## CROWN POINT COMMUNITY SCHOOL CORPORATION -ATHLETIC TURF IMPROVEMENTS Crown Point, IN 46307

## ADDENDUM THREE

Addendum Two (AD.03) to the drawings and specifications prepared by Gibraltar Design and The Skillman Corporation for Crown Point Community School Corporation – Athletic Turf Improvements for Crown Point Community School Corporation, Crown Point, Indiana.

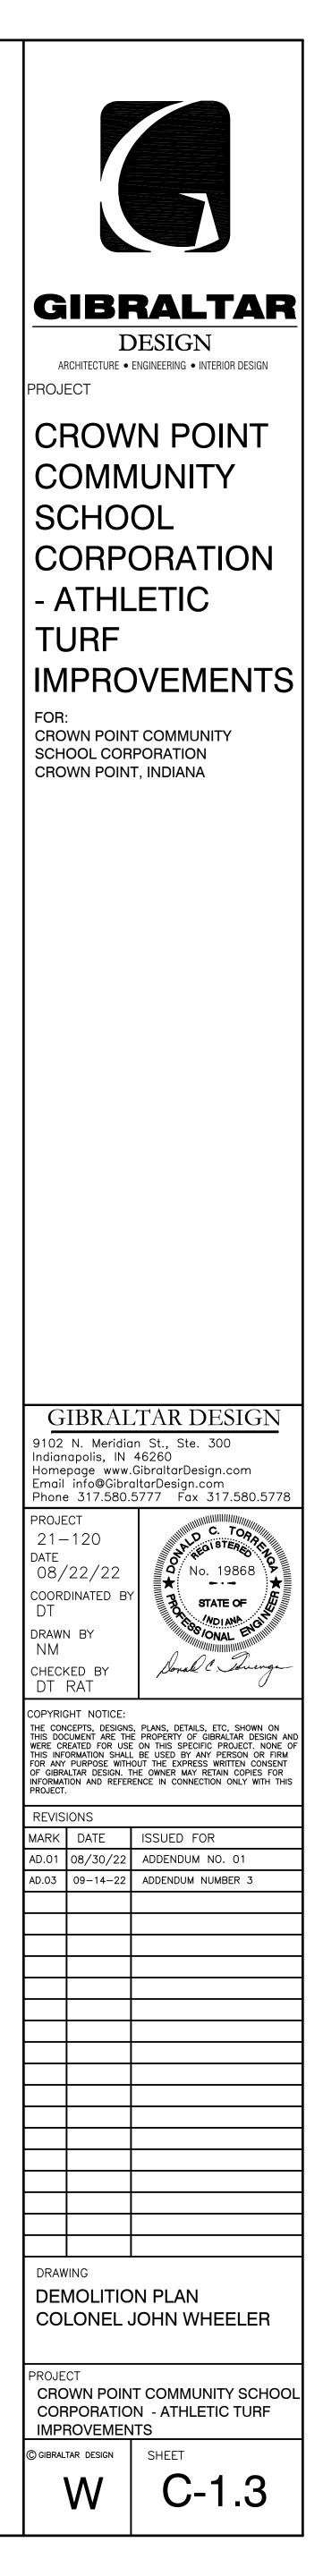
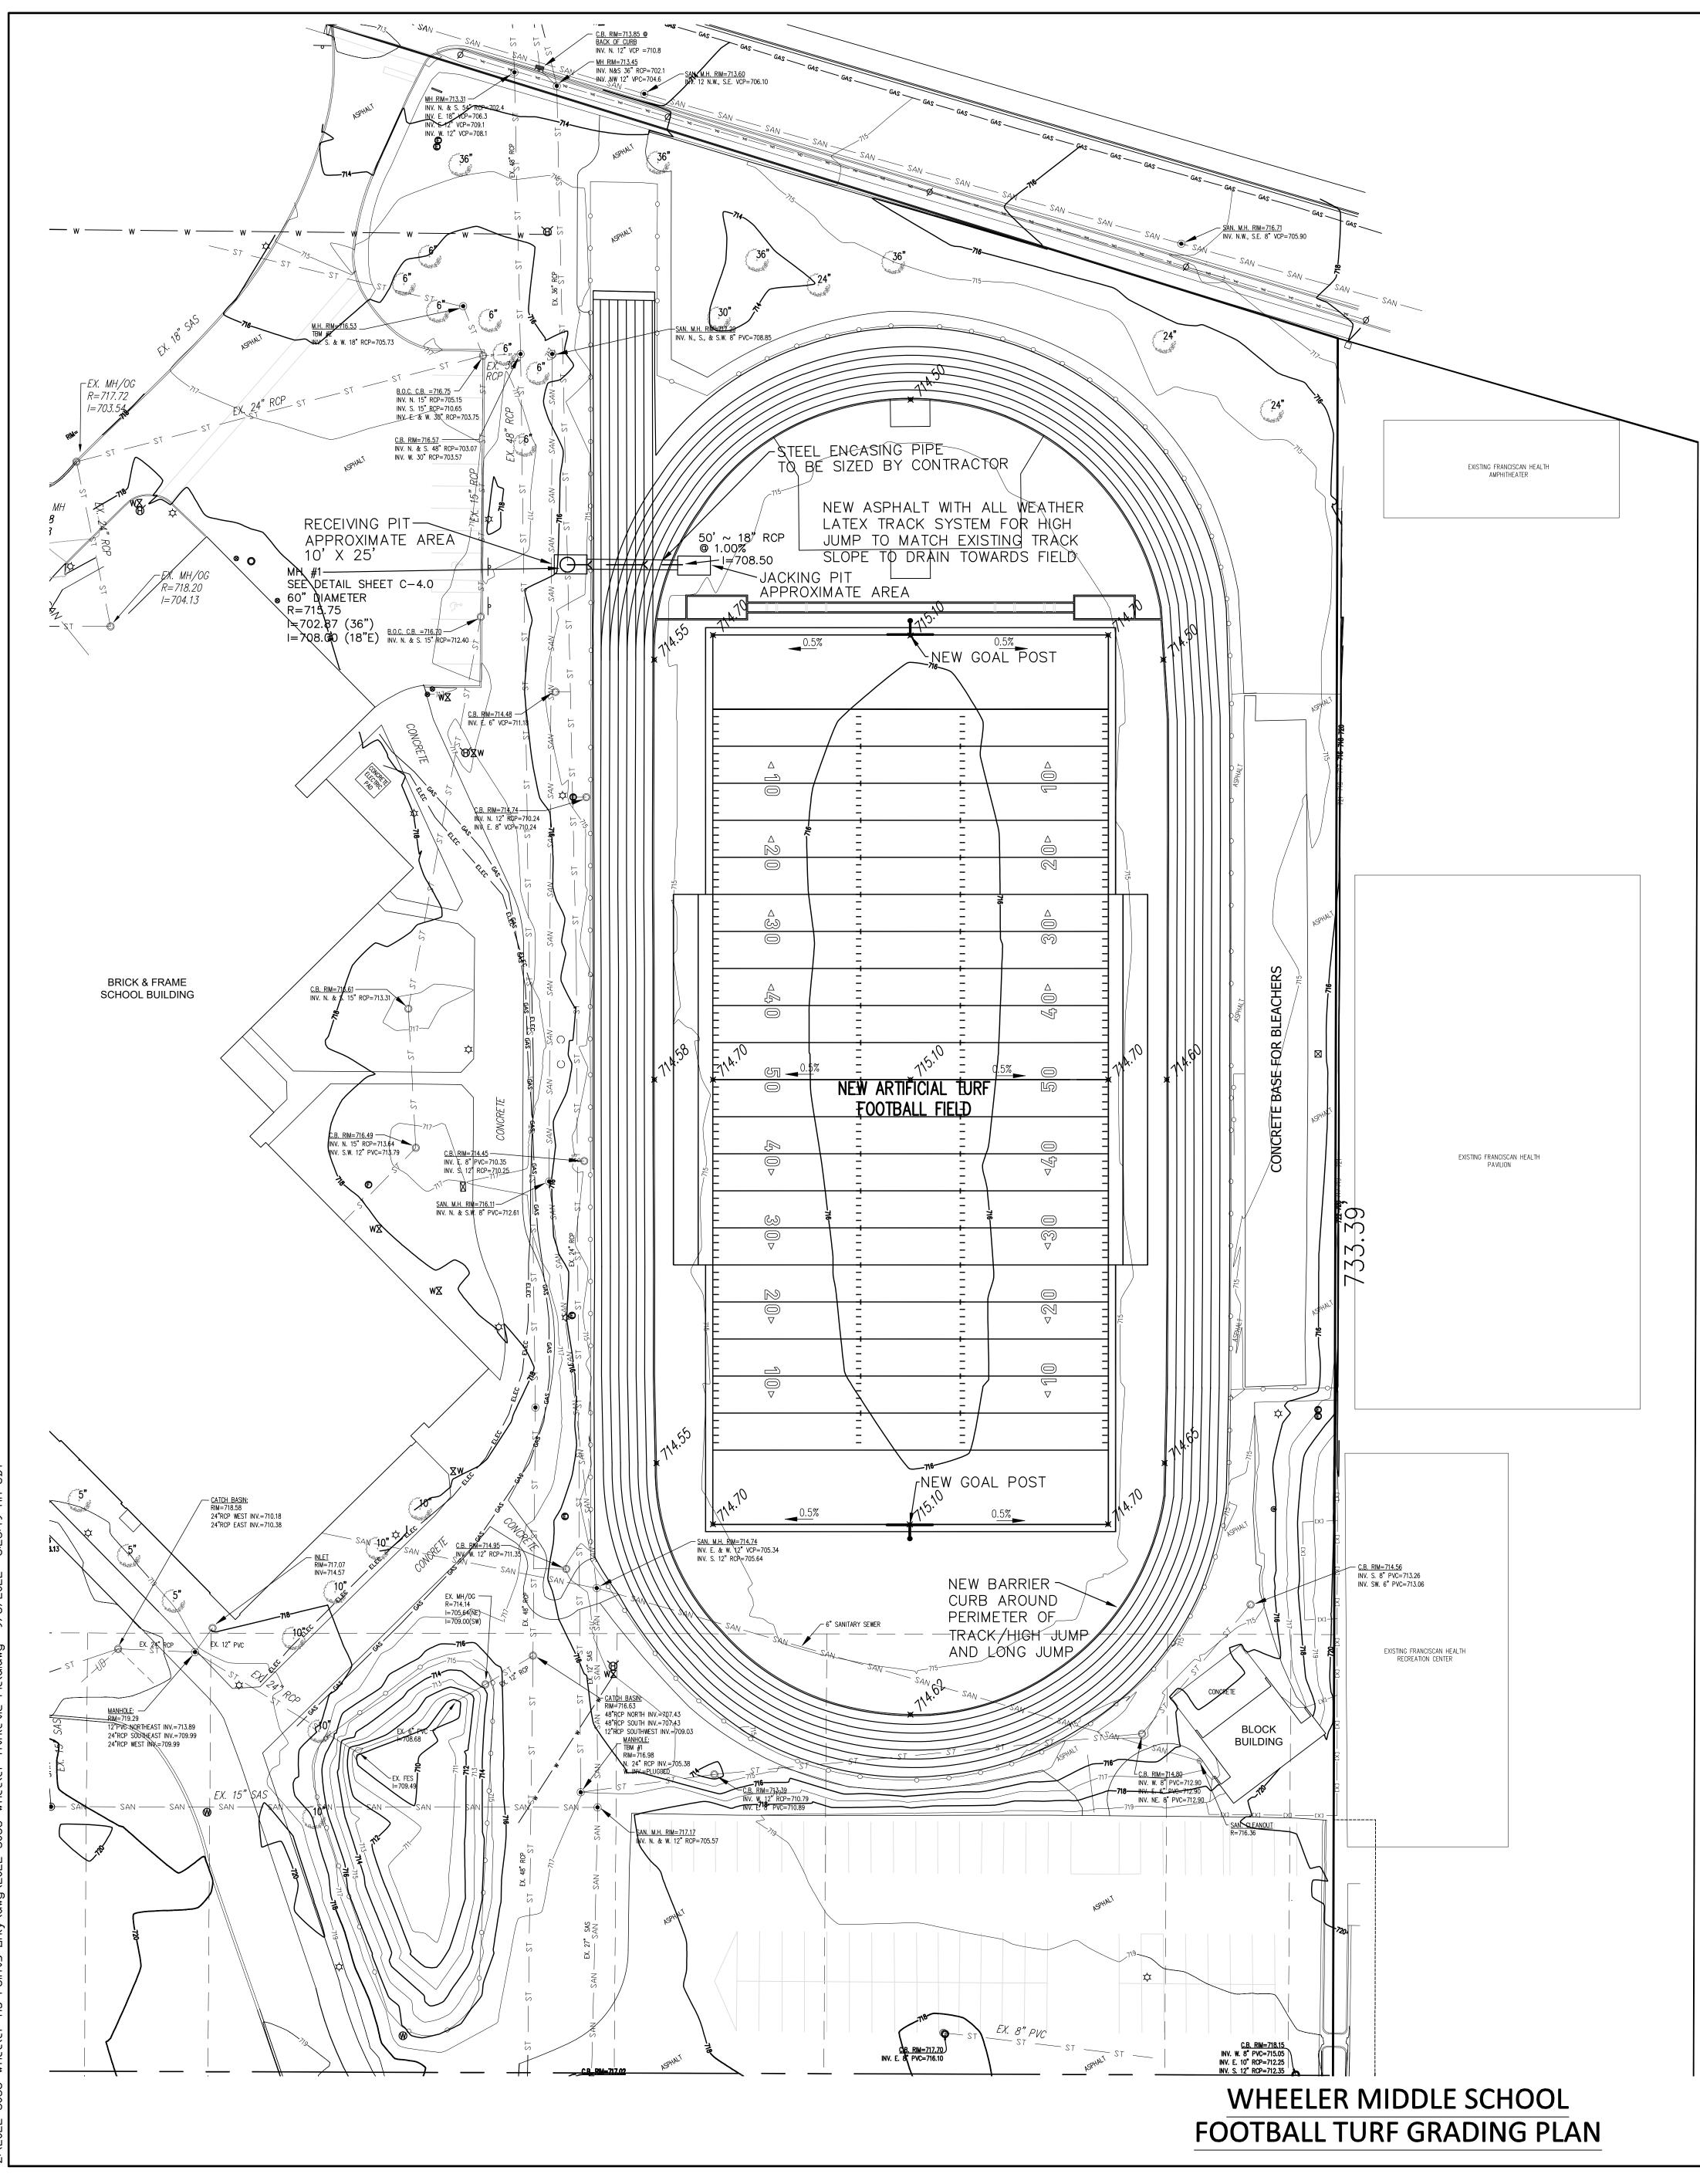
~~~	NOTE:	AD.03
	1) THE EXISTING PVC DRAIN PIPES ARE TO BE CUT OFF 1.5 FEET BELOW THE PROPOSED SURFACE OF THE ARTIFICIAL TURF FIELD. THE OPEN END OF EACH PIPE SHALL BE COVERED WITH A SUITABLE SOLID CLOSED PVC LID AND FIRMLY SECURED TO THE PIPE WITH PVC CEMENT.	
	2) REMOVE ALL EXISTING 4" PVC DRAIN PIPE SURROUNDING THE FOOTBALL FIELD AND SECURELY PLUG THE TWO EXISTING CONNECTIONS UNDER THE EXISTING TRACK AT THE CATCH BASINS AND ON THE INSIDE OF THE TRACK. FILL EXISTING PIPE UNDER THE TRACK WITH FLOWABLE FILL.	
	~~~~~~~~~~~~~~~~~~~~~~~~~~~~~~~~~~~~~~~

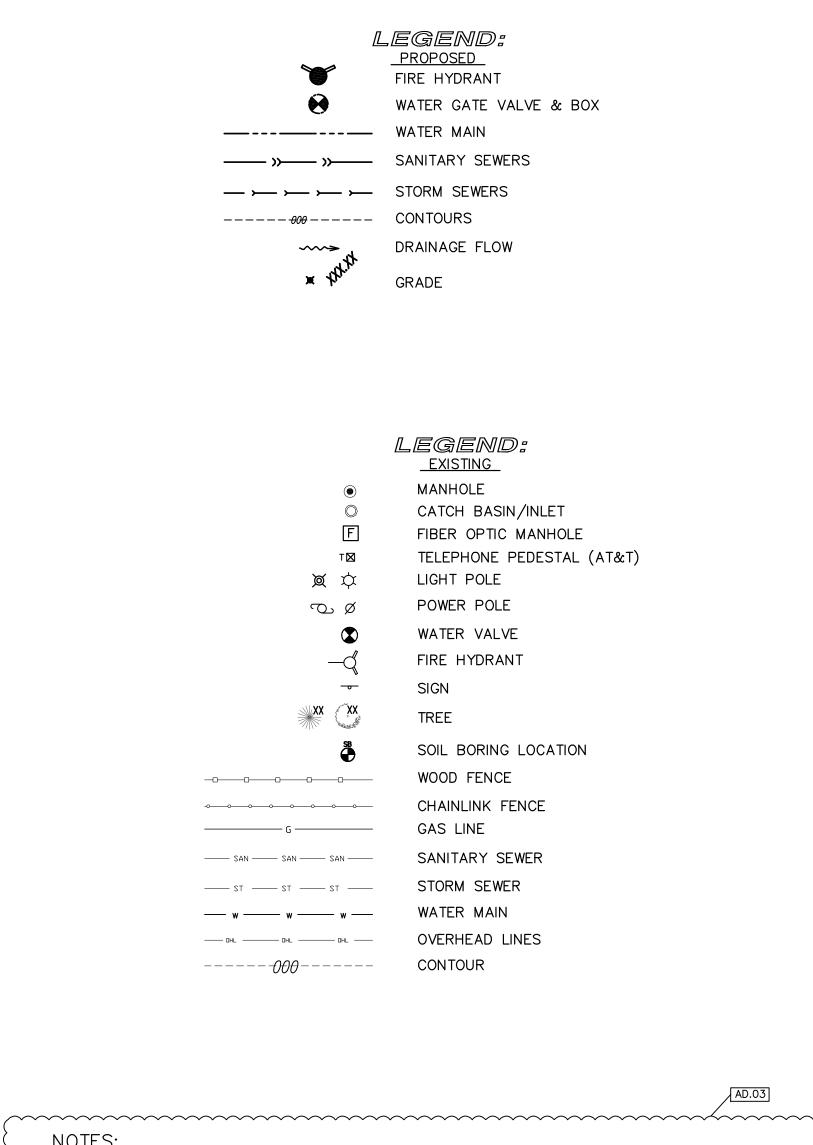
NOTES:
	1) THE EXISTING TRACK SURFACE IS NOT TO BE DISTURBED. IF DAMAGE IS DONE TO THE SURFACE THE CONTRACTOR SHALL REPAIR IN KIND AT THEIR COST.
	2) THE CONTRACOR SHALL EXCAVATE THE EXISTING FOOTBALL FIELD AREA WITHIN THE PERIMETER OF THE EXISTING TRACK TO A DEPTH OF MINIMUM 20 BELOW THE FINISHED GRADES AS SHOWN ON THE GRADING PLAN.
	3) SPECIAL CARE SHOULD BE TAKEN TO CONSTRUCT THE VARIOUS SECTIONS OF THE FIELD IN ACCORDANCE WITH THE CROSS SECTIONS FOR EACH AREA OF CONSTRUCTION. REFER TO THE SHEETS $C-4.0$ AND $C-4.1$ FOR THE SPECIFIC CROSS SECTIONS.
~~ 	AD.03
